Model: Schmidt3			Dat	Date: 31-Oct-99		No.: RH547001	
Subject: New Functions in the Schmidt3 G4 Unit				Prepared by: K. Misugi		•	
From: Technical Service Dept., GTS Division							
Classification:			orma	tion	Action	required	
	☐ Mechanical	☐ Electric	al		⊠ Servic	ce manual revision	
	☐ Paper path	Transm	it/rec	eive	Retrof	fit information	
	Other ()

This RTB informs the changes made to the G4 (SiG4) unit software and corrections to the Schmidt3 ISDN Unit service manual.

Model: Schmidt 3		Date: 31-Oct-99		No.: RH547002	
Subject: Group dials display on RDS				Prepared by: K. N	Moriizumi
From: Technical Service Dept., GTS Division					
Classification:	☐ Troubleshooting	☐ Part info	orma'	tion Action	n required
	☐ Mechanical	☐ Electrica	al	☐ Servi	ce manual revision
	☐ Paper path	Transm	it/rec	eive Retro	fit information
	☐ Other ()

Model: Schmidt3 Dat			ate: 29-Feb-00		No.: RH547006a	
Subject: Firmware modification history				Prepared by: Y. Okunishi		
From: Technical Services Dept., GTS Division						
Classification:	☐ Troubleshooting	☐ Part info	orma	tion	Action	required
		☐ Electric	al		Servic	e manual revision
	☐ Paper path	☐ Transm	it/rec	eive	Retrof	fit information
	⊠ Other ()

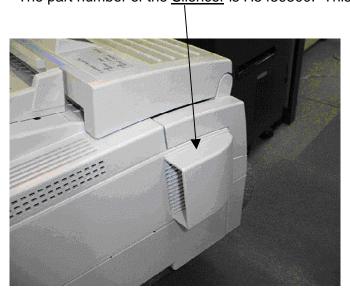
The noise level of the machine is within standard parameters. However, some customers do not like the noise generated by the fan, as the machine is sometimes installed on or by a desk.

We have prepared the following countermeasure to reduce the noise from the fan:

1) New ROM H5457200J (See MB no. MH545008.) --- Only for Schmidt 1. This reduces the noise level of the fan by about 20% during printing.

- The running time of the fan is longer than the original time using the old ROM.
- We cannot change the fan control in Schmidt 3.
- 2) Silencer

We will provide a special part called a "Silencer" which can be set at the air exit near the fan by the customer. (See below)

This will reduce the noise from the fan.

The part number of the Silencer is H5459500. This part will be available soon at SPC.
